# Staff Report

To: Salt Lake City Planning Commission  
From: Doug Dansie, AICP, 801 535-6182  
Date: November 12, 2014  
Re: PLNSUB2014-00522 Ken Garff Planned Development

**REQUEST:** The petitioner, Ken Garff, represented by Curtis Miner, is for a planned development located at 525 South State Street – The proposal is to create a unified auto dealership complex with multiple automobile showrooms with cross access easements for the entire site and includes a request for modification to the landscaping and signage requirements of the zoning ordinance. The proposed site is located in the D-2 Downtown District and is located within Council District 4, represented by Luke Garrott. (Staff contact: Doug Dansie at (801) 535-6182 or [doug.dansie@slcgov.com](mailto:doug.dansie@slcgov.com)).

COMPOSITE  
MASTER SITE PLAN  
SHEET 1 OF 2

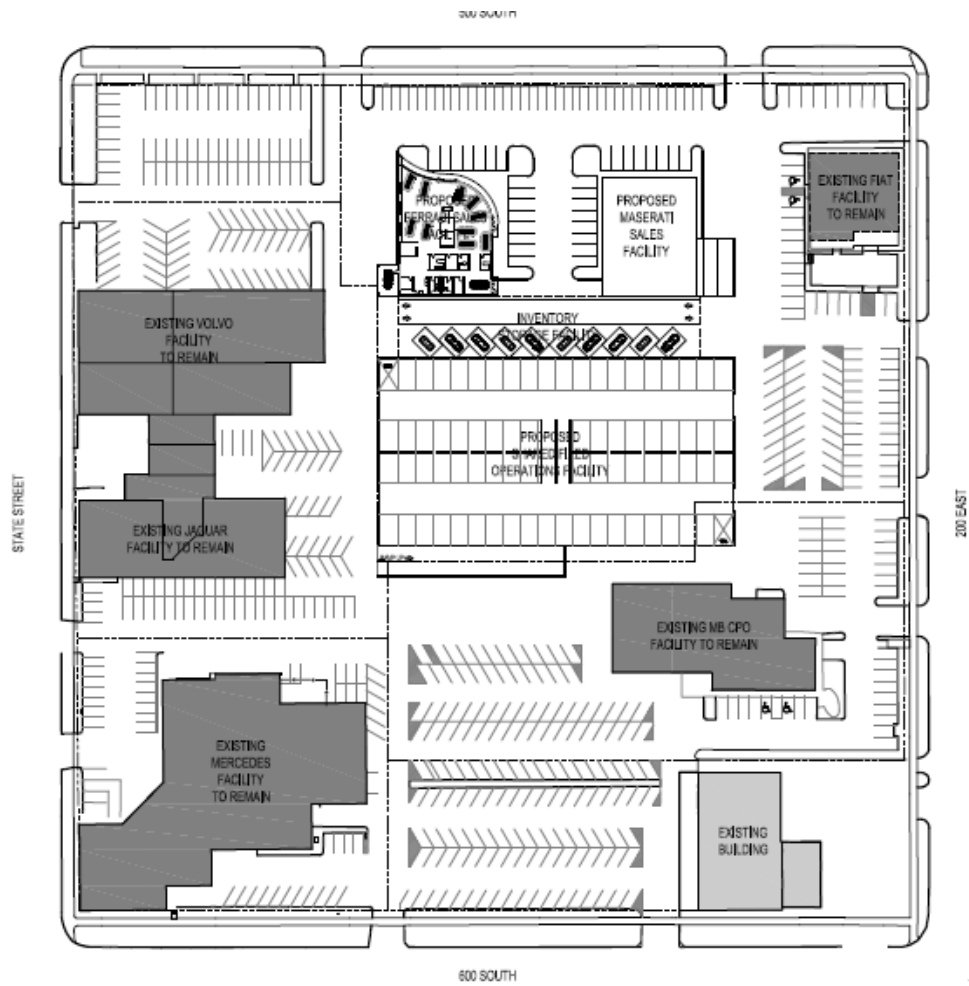
**Recommendation:** Landscaping requirements for the auto display area is not required. Landscaping for other areas, including parking, may be consolidated. Park strip trees are required, but spacing may be modified as per ordinance. There is no landscaped setback requirement from the front property line. (but the public park strip is to be landscaped).

Garff does not desire to have trees overhanging their autos on display for both visual and maintenance reasons and has asked that they be able to reduce and/or consolidate the landscaping to the perimeter of the lot or in landscape “islands”. The ordinance specifically prohibits counting perimeter landscaping towards this requirement, however there is technically no perimeter landscaping is required (see below).

It would be a reasonable compromise to require landscaping on only those areas that are “parking” and reduce trees in the areas for display.

Since there are street trees on three of the four block faces and 500 South has an extra wide park strip that would easily accommodate trees Staff recommends no modification to present code.

3. Landscaping: Trees are not required within the auto display area and landscaping is allowed to be consolidated in remaining areas. Street trees are required as per city code (and location may be adjusted in consultation with the City Forester).
